# Modification Application - Regulation 22

<b>Interest Holder</b>	Central Petroleum Limited	<b>EMP Title</b>	NT Drilling Campaign	<b>Unique EMP ID No.</b>	CTP 3.4	<b>Mod No.</b>	3	<b>Date</b>	29 March 2021
<b>Brief Description</b>	<p>The NT Drilling Campaign EMP was approved by the minister on 29 November 2020. The plan included the development of well pads, access tracks and the associated infrastructure necessary to drill 2 development wells (WM27 and WM28) at Mereenie.</p> <p>In relation to the WM28 well, Central would like to modify the access track route to the well pad as approved in the EMP. The modification is necessary as Sacred Site Clearance Certificate (SSCC) (C2020-009 - Appendix A) issued on 23 February 2021 by the Central Land Council (CLC) required under our land access agreement differs from the authority certificate (C2020/084 - Appendix B) granted on 25 November 2020 by the Aboriginal Areas Protection Authority (AAPA).</p> <p>It has now been communicated by the Aboriginal Areas Protection Authority (AAPA) that the requested variation will not be approved and that an alternative access route be identified. Therefore, Central is proposing to utilise the approved a

### West Mereenie 28

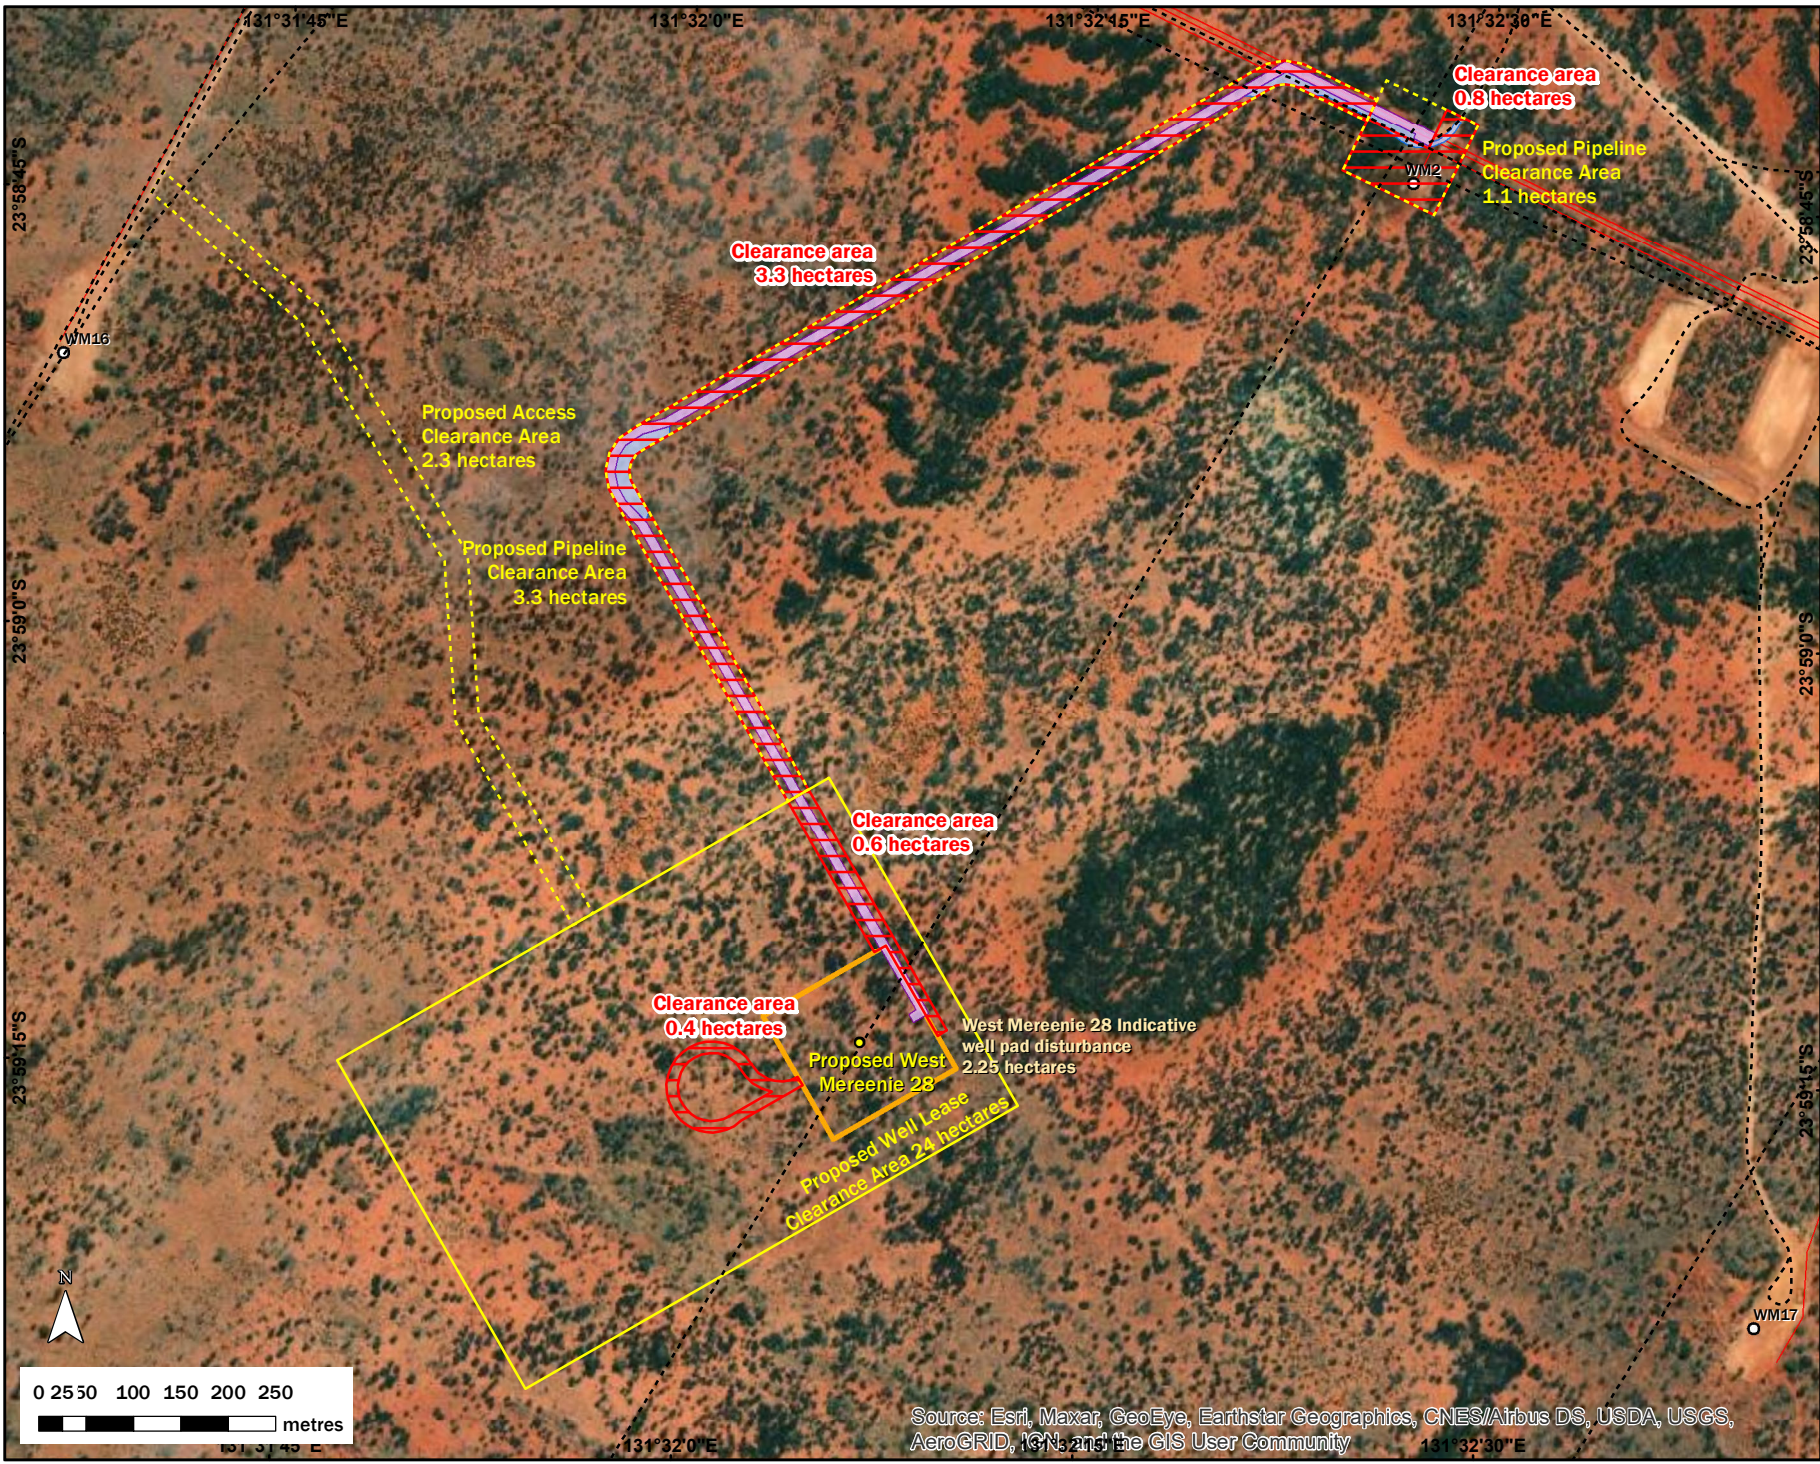
<p><b>Figure 4-3 – Clearance Area (West Mereenie 28 Well)</b></p>	<p><b>Figure 4-3 – New Clearance Area (West Mereenie 28 Well)</b></p> <p>This figure has been updated to highlight the use of the ROW as the new route for the flow line and the access track to the WM-28 well (Appendix C). The new route has been cleared by the CLC and AAPA.</p>
<p><b>Figure 5-15 Land Types (West Mereenie 28 Well)</b></p>	<p><b>Figure 5-15 Land Types (West Mereenie 28 Well)</b></p> <p>The entire ROW highlighted on this map will be cleared and used for the access track and flow line. Additional clearing highlighted in (Appendix C) will be needed. The new route along the ROW has been cleared by the CLC and AAPA.</p>
<p><b>Risk Register – Failure of flow lines</b></p> <p><b>Aboveground Flowlines</b></p> <ul style="list-style-type: none"> <li>West Mereenie wells - the flowlines are not co-located with the access track to decrease likelihood of accidental vehicle damage (engineering)</li> </ul>	<p><b>Risk Register – Failure of flow lines</b></p> <p><b>Aboveground Flowlines</b></p> <ul style="list-style-type: none"> <li>West Mereenie 27 well - the flowline is not co-located with the access track to decrease likelihood of accidental vehicle damage (engineering)</li> <li>West Mereenie 28 well - the flowline is co-located with the access track. The line will not be live at any time during well pad development, mobilisation, drilling and demobilisation when the right of ROW would be used. There will be sufficient separate between the flowline and the access track for use during operational activities. Therefore, the likelihood of any release as a result of accidental vehicle damage will be minimised.</li> </ul>
